Re: Cedar Apartments
541, 543, 545 Cedar SW. Albuquerque, NM 87106
Traffic Circulation Layout
Engineer's/Architect's Stamp 07-11-18 (K15-D062)

Based upon the information provided in your submittal received 07-11-18, the above referenced plan cannot be approved for Building Permit until the following comments are addressed:

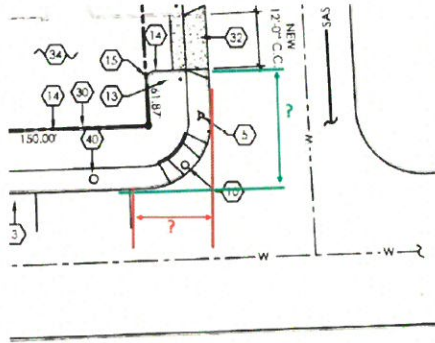
9. Please provide dimension detail of the distances of the curb to the street parking and to the curb cut in the SE corner of the lot. The minimum required distance from the curb to the street parking is 20' and from the curb to the curb cut is 25'.

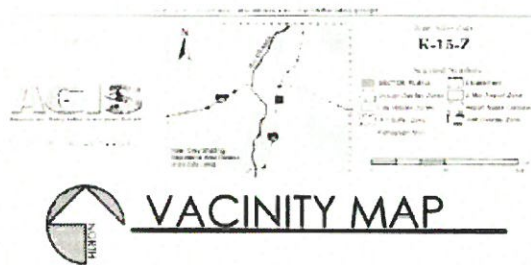
10. Please note that on street parking should not interfere the clear sight triangle.
11. Please Correct the spelling on the "Vicinity Map" as shown:
